Access Compliance Report

Public Rights-of-Way

Intersection ID: 2591	Main Street: BEARDSLEY_DR	Cross Street: HARTFIELD_DOWNS_DR	Location: SE
ADA ID: B198030C0FC6	Ramp Type: Perp	Initial Pass/Fail: Fail	Overall Compliance: No
Codes/Mitigation Info/Possible Solution			Severity Score: 35
			Field Measurements/Component Compliance

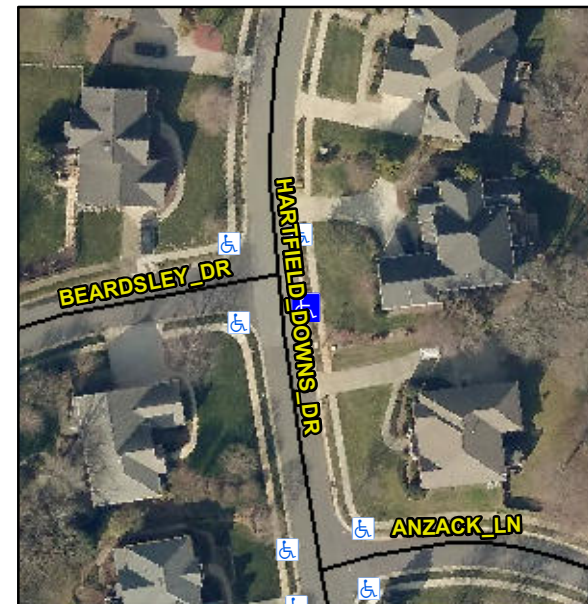
Not Found, R304.5.1, R304.2.2

Compliance	Description	Data	Compliance	Description	Data
N/A	Ramp Length (in)	48.0	No	Ramp Slope (%)	12.6
No	Ramp Width (in)	46.0	Yes	Ramp XSlope (%)	2.4
N/A	Flare Type LT	N/A	N/A	Flare Type RT	N/A
N/A	Flare Slope LT (%)	N/A	N/A	Flare Slope RT (%)	N/A
N/A	Flare Traversable LT?	N/A	N/A	Flare Traversable RT?	N/A
N/A	Landing Length (in)	N/A	N/A	DWS Provided?	N/A
N/A	Landing Width (in)	N/A	N/A	DWS Contrast?	N/A
N/A	Landing Slope (%)	N/A	N/A	DWS Length (in)	N/A
N/A	Landing X Slope (%)	N/A	N/A	DWS Full Width?	N/A
N/A	Landing Curb? (Y/N)	N/A	N/A	DWS Offset (in)	N/A
N/A	Shared Landing?	N/A			
N/A	Gutter Ponding?	N/A	N/A	Gutter Slope (%)	N/A
N/A	Gutter Lip Ht (in)	N/A	N/A	Gutter X Slope (%)	N/A
N/A	Painted X Walk1?	No	N/A	Painted X Walk2?	N/A
	X Walk 1 Direction	To W		X Walk 2 Direction	N/A
N/A	X Walk 1 Width (in)	N/A	N/A	X Walk 2 Width (in)	N/A
	X Walk 1 Slope (%)	3.2		X Walk 2 Slope (%)	N/A
	X Walk 1 X Slope (%)	4.2		X Walk 2 X Slope (%)	N/A

Remove & Replace Entire Ramp.
